REC CAMPUS EXPANSION
PICKLEBALL COURT
 2686 S GOLIAD ST (SH 205)
 ROCKWALL, TX 75032

SP2024-046: Site Plan for 2686 S. Goliad Street

PROJECT NUMBER: SP2024-046
PROJECT NAME: Site Plan for 2686 S. Goliad Street
SITE ADDRESS/LOCATIONS: 2686 S GOLIAD ST

CASE CAPTION: Discuss and consider a request by Frank Polma, PE of R-Delta Engineers, Inc. on behalf of Stephen Geiger Rayburn County Electric Cooperative for the approval of a Site Plan for Private Recreation Facilities on a 1.57-acre parcel of land identified as Lot 1, Block A, Estep Subdivision, City of Rockwall, Rockwall County, Texas, zoned Planned Development District 44 (PD-44) for Commercial (C) District land uses, situated within the SH-205 Overlay (SH-205 OV) District, addressed as 2686 S. Goliad Street [SH-205], and take any action necessary.

CASE #
CITY SITE PLAN SUBMITTAL

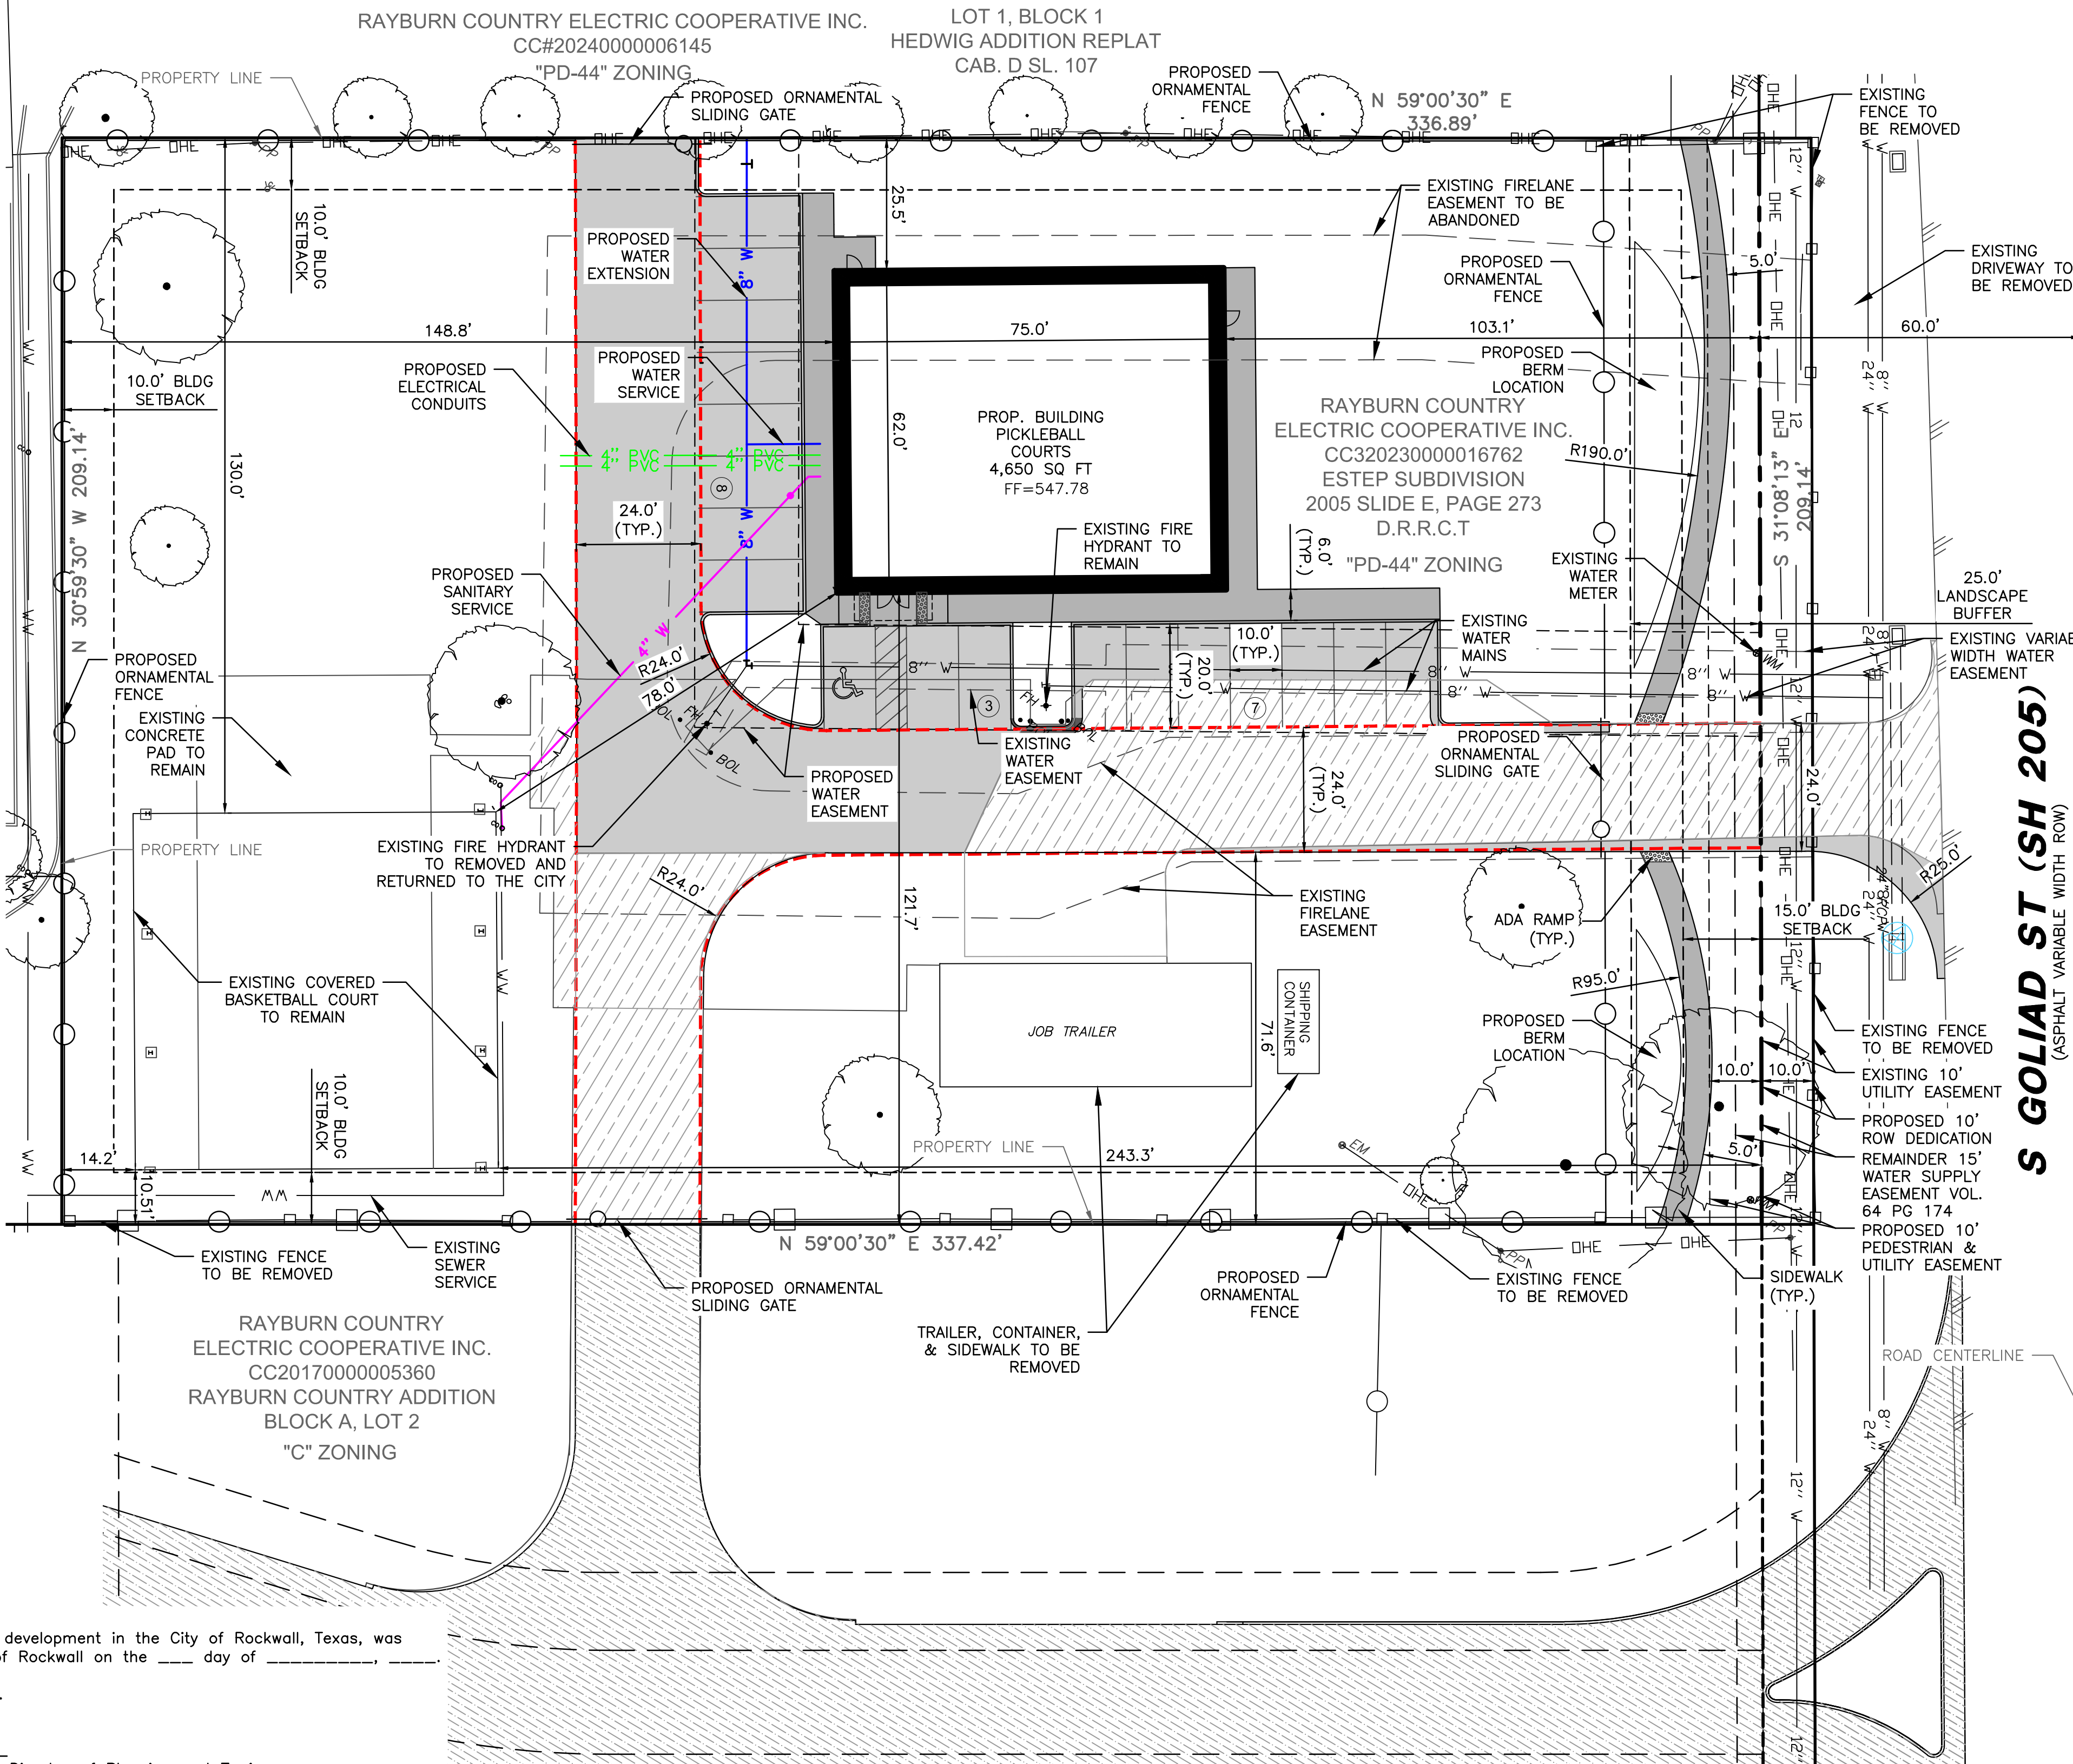
M.6 Site Plan.

- (1) Please only delineate the building setback adjacent to S. Goliad Street. In addition, the front building setback is 25-feet. (Subsection 03.04.B, of Article 11, UDC)
- (2) Please verify how many courts will be within the facility. Based on the parking requirements shown on the site plan, there would only be two (2) courts within the building.

- (3) Please indicate the height of the proposed fencing and gates. In addition, please provide a detail of the fence and gates. (Subsection 0308.02.F, of Article 08, UDC)

- (4) Please indicate any ground mounted equipment. On the landscape plan provide the necessary five (5) gallon evergreen shrubs for screening. (Subsection 01.05. C, of Article 05, UDC)

- (5) Please clarify if there will be any RTUs. If so, they must be crosshatched on the building elevations. (Subsection 01.05. C, of Article 05, UDC)
- (6) Provide a note that there will be no outside storage or above ground storage tanks. (Subsection 01.05. D, of Article 05, UDC)

- (7) Please clarify the dumpster situation. Will there be a dumpster enclosure or will poly carts be used? Please note that poly carts must be stored within the building, and if a dumpster enclosure is proposed it must be shown on the site plan and a detail (including elevations) must be provided. (Subsection 01.05, of Article 05, UDC)

- 11/19/2024: 1. Will need a looped water main - cannot dead end this main. Is it tying into an existing main? Please clarify.
2. Fence shall "straddle" the water line easement. No poles or structures allowed in easements.
 3. Shift location so that meter is not in parking stall or sidewalk next to the building.
 4. All site drainage must go to the existing detention system.
 5. Check with the Fire Marshal to make sure that you don't need additional fire hydrants.
 6. Min 10' island
 7. Dead end fire lane is too long without a Fire Department turn around
 8. Currently not a fire lane. Need to plat as fire lane
